Access Compliance Report

Public Rights-of-Way

Intersection ID: 29320	Main Street: N_TRYON_ST	Cross Street: UNIVERSITY_EXECUTIVE_PARK_DR	Location: SW
ADA ID: 77184DFC0FC4	Ramp Type: Directional1	Initial Pass/Fail: Pass	Overall Compliance: No
		Severity Score: 0

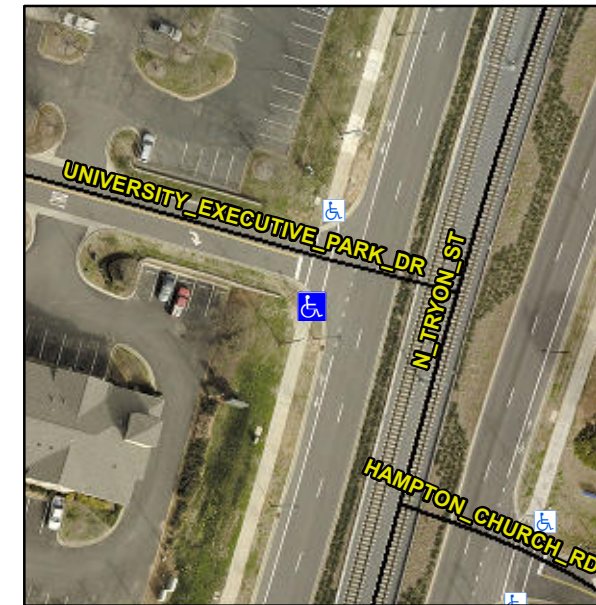
R304.2.2-Perp, R304.3.2-Para

Remove & Replace Landing.
